RE: Review of the Sonoita Creek Mitigation Project Proposal for the Proposed Rosemont Copper Mine

Review of the Sonoita Creek Mitigation Project Proposal for the Proposed Rosemont Copper Mine

G. Mathias Kondolf, PhD
2241 Ward Street, Berkeley CA
mattkondolf@gmail.com

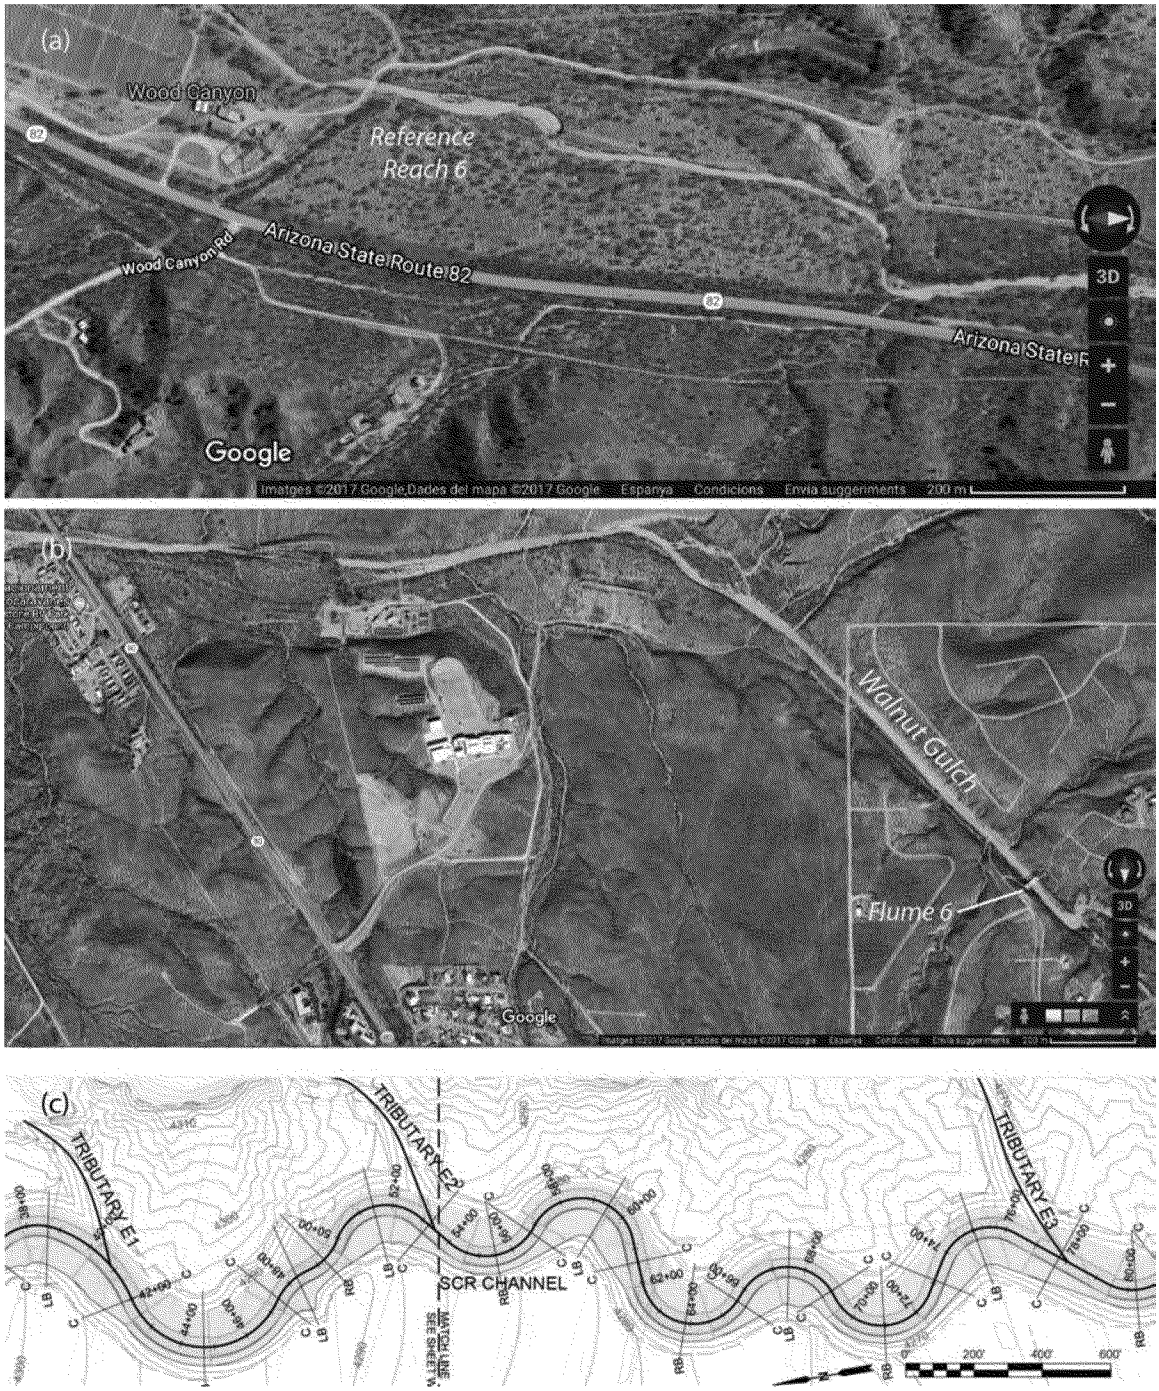
WET (2017:25) states that the reconstructed channel sinuosity "mimics the measured sinuosity of natural, least-altered reaches of Sonoita Creek…Typical values of sinuosity observed in the least altered reaches of Sonoita Creek ranged from 1.1 to 1.4." This statement is not true. The asserted values do not agree with my independent measurements of sinuosity for the existing reaches of Sonoita Creek. For Sonoita Creek in Rail X Ranch, I measured a sinuosity of 1.07; from 'Reference Reach 6' downstream to the point where Sonoita Creek becomes adjacent to Hwy 82, a sinuosity of 1.07 (Figure 1a); and from the end of the Hwy 82 adjacent section to the road crossing downstream of Reference Reach 8, a sinuosity of 1.29. The latter value is exceptional, occurring only in this more sinuous and dynamic reach. The "typical" values are certainly lower, and well represented by the measured 1.07. Sinuosity does not reach 1.4 on these reaches of Sonoita Creek. At the Reference site 6, which was used by WET (2017) as a basis for design of the proposed channel reconstruction, the channel is nearly straight, as reflected in the measured sinuosity of 1.07.

Similarly, WET (2017) also uses Walnut Gulch near Flume 6, in the Walnut Gulch Experimental Watershed near Tombstone, Arizona, as a reference reach (Figure 1b). This reach is almost perfectly straight before going through an approximately 30-degree bend to the left, and thus depending on the length of reach selected, its sinuosity could be as low as 1.0 (taking only the straightaway before the bend), or about 1.07 (including the bend and continuing downstream to the highway bridge). Thus, this reference reach does not provide support for a highly sinuous channel design on Sonoita Creek.

WET (2017:25) states "The restored channels have a sinuosity that ranges from 1.1 to 1.2." This is false. The proposed channel design is much more sinuous than asserted in this statement, much more sinuous than the existing channels in Sonoita Creek, and more sinuous than the reference reaches in Sonoita Creek and Walnut Gulch (Figure 1).

The proposed meandering channel has a sinuosity of about 1.39, as measured from Tributary E1 confluence to the Tributary E3 confluence (Figure 1c). This would be a very large increase in sinuosity over the typical sinuosity of 1.07 prevailing today. This has significant implications for the proposed mitigation project. As discussed below, to build a channel with such an artificially high sinuosity imposed is likely unsustainable, and after a few moderate storms, the result would probably be that the meander bends wash out, leaving a shorter, straighter channel.
